2006 INTERNATIONAL BUILDING CODE DOCUMENTATION

MEANS OF EGRESS

Code Change No: **E5-06/07**

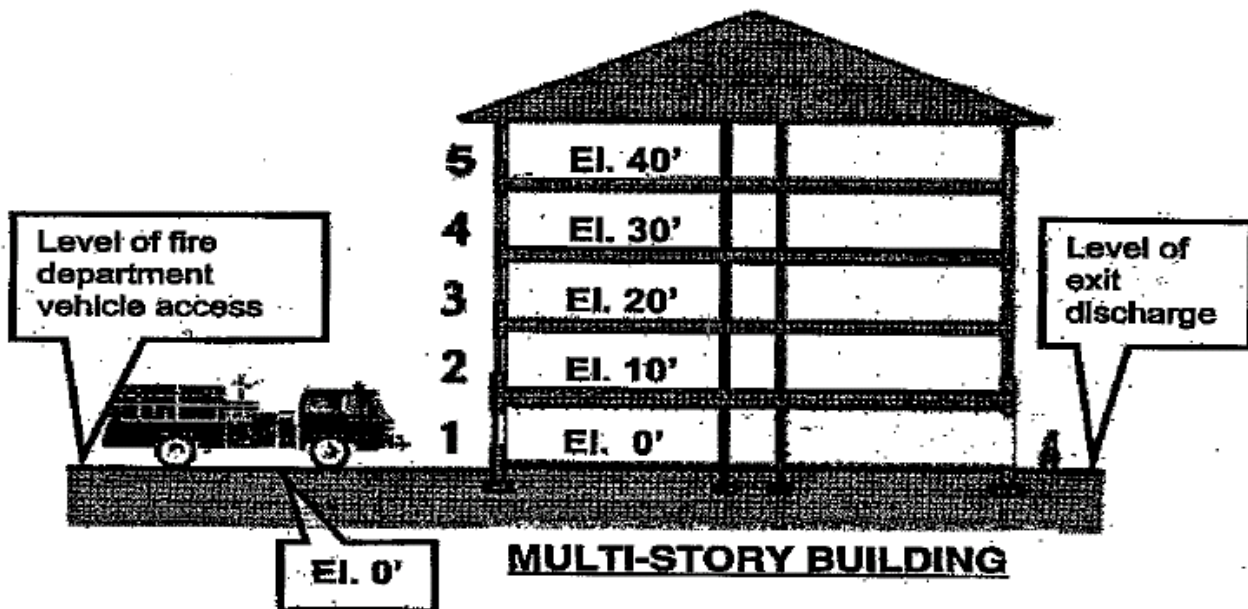
EXIT DISCHARGE, LEVEL OF. The ~~horizontal plane located~~ lowest story at the point at which an exit terminates and an exit discharge begins.

The level of exit discharge as shown in the attached drawing of a Multi-Story Building is at elevation 0.0', the first floor level of the building is also at elevation 0.0'; therefore, the level of exit discharge and the first floor level of the building are at the same elevation. The first story of the building begins at elevation 0.0' (first floor) and extends to the elevation 10.0' (second floor). The first story of the building is the first story above the level of exit discharge."

The major difference between the IFC formal interpretations and the NFPA 101 definition is that NFPA 101 defines the "level of exit discharge" as a volume (story), not as a "horizontal plane". Therefore, in the diagram of the multistory building above, the "first story above the level of exit discharge" under NFPA 101 (and for that matter, as used under the legacy codes) was always considered the second story (El. 10'). However, under the IFC Formal Interpretations, it is now the first story (El. 0').

EXIT DISCHARGE, LEVEL OF. The ~~lowest~~ story at the point at which an exit terminates and an exit discharge begins.

Committee Reason: The revised language will clarify that the level of exit discharge is the story the occupants are egressing from rather than the floor they are walking on. The modification was made because the story could be the lowest, highest or any level of building.

The following details are taken from the above referenced ICC and ICBO publications.

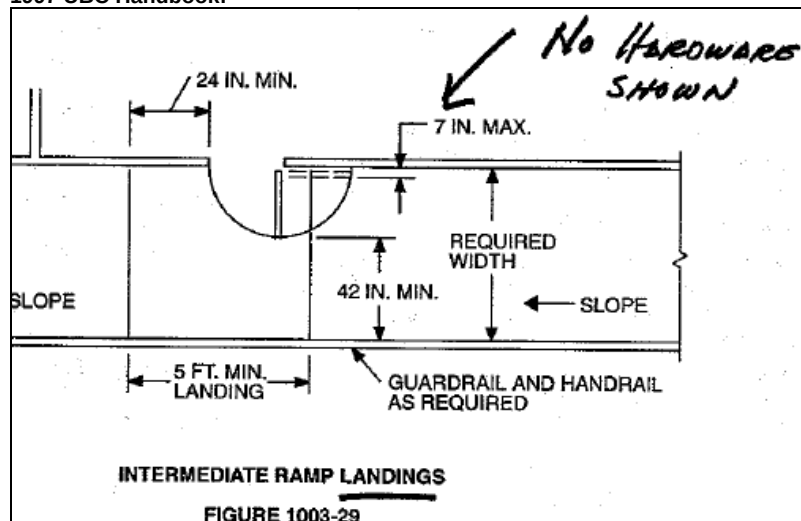
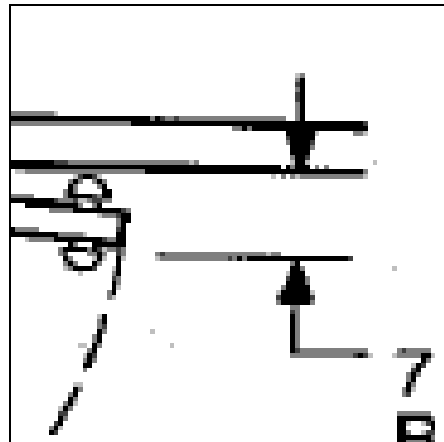
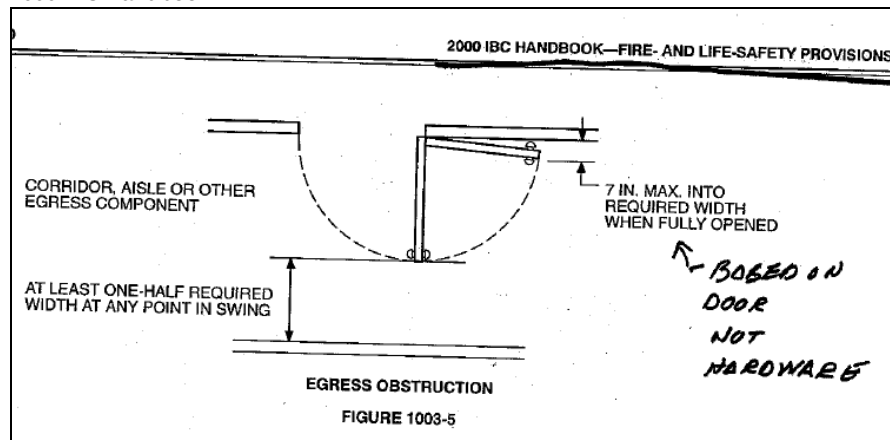
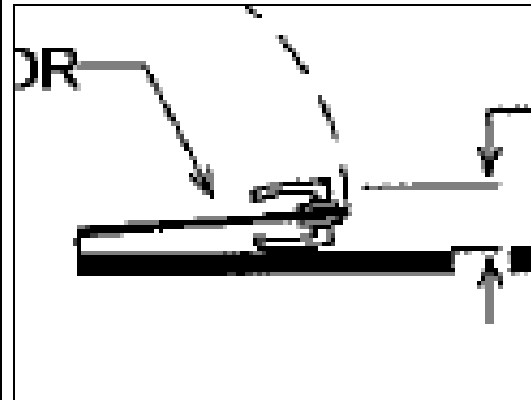
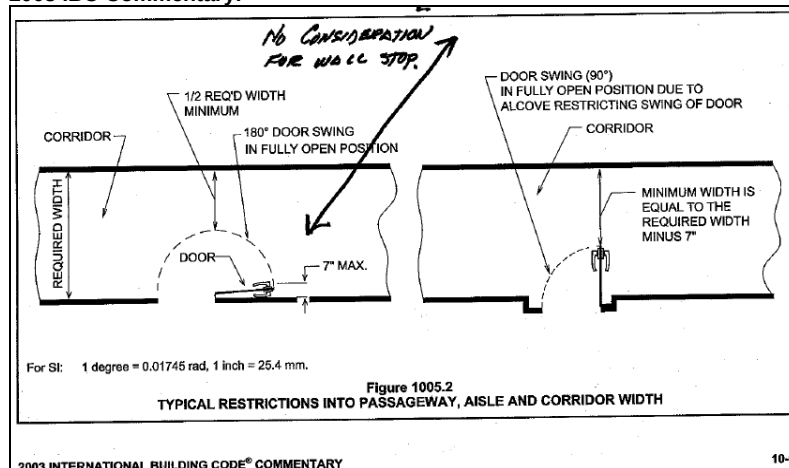
Commenter's Reason: The IFC and IBC requirements for door encroachment have not clearly addressed the issue of attached door latching hardware. The intent of the proposal as submitted was to clarify that door latching hardware should not be included in the dimensional requirement for door encroachment. The committee discussion and stated reasons for disapproval of E17 demonstrate the confusion surrounding this requirement. This public comment separates the door encroachment requirement from hardware, but adds restrictions on the height and mounting surface to capture the appropriate hardware encroachment prescriptions. The additional text is taken from NFPA 101 means of egress requirements.

The best illustration of just how confusing the current text is, and the best justification for this needed clarification, are the ICC Commentaries. The 7" door encroachment requirement is based upon legacy code provisions and has survived intact. In the *1997 UBC Handbook*, figure 1003-29 provides a detail with a dimension indicating a maximum of 7" door encroachment, but the figure shows no hardware and the dimension line leads to the edge of the door surface. Fast-forward to the *2000 IBC Handbook Fire and Life-safety Provisions* and to figure 1003-5. In this detail, hardware has been added to the illustration but the 7" dimension line has moved to some vague point between the door slab and the doorknob. In the *2003 IBC Commentary Figure 1005.2*, the detail has been modified to show accessible hardware instead of a doorknob, but the dimension line again leads to some vague spot on the door latch.

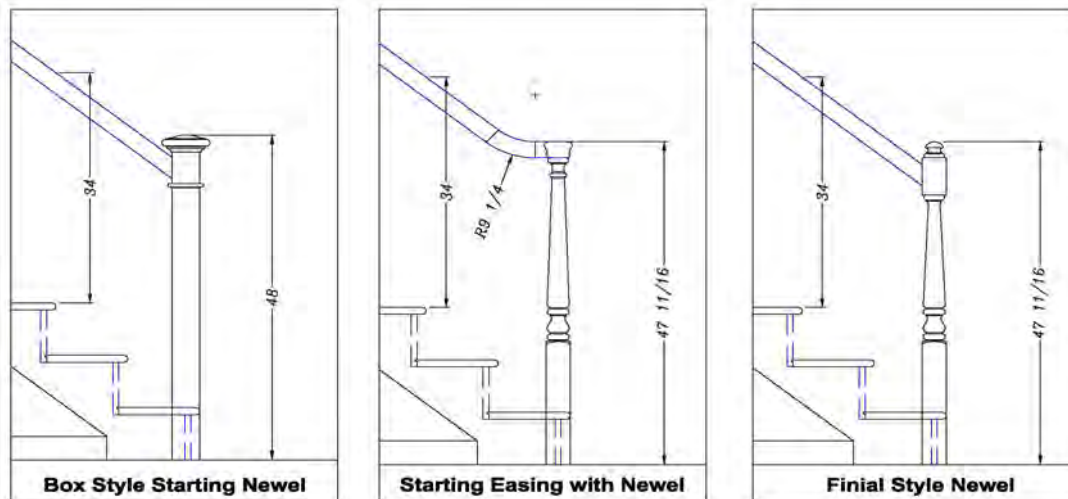
1. Handrails within dwelling units are permitted to be interrupted by a newel post at a turn stair landing.
2. Within a dwelling unit, the use of a volute, turnout, ~~or~~ starting easing or starting newel is allowed ~~on~~ over the lowest tread.
3. Handrail brackets or balusters attached to the bottom surface of the handrail that do not project horizontally beyond the sides of the handrail within 1.5 inches (38 mm) of the bottom of the handrail shall not be considered obstructions. For each 0.5 inch (12.7 mm) of additional handrail perimeter dimension above 4 inches (102 mm), the vertical clearance dimension of 1.5 inches (38 mm) shall be permitted to be reduced by 0.125 inch (3 mm).

Reason: The proposed change will make editorial corrections required as well as clarify the use of newels

The need to allow the use of a newel at intersections of the rail in dwelling units at a turn in the stair to provide for the use of newels within a flight has been recognized and allowed within the IRC and should be included in the IBC to allow lower cost options that have not caused any known attributable safety issues.
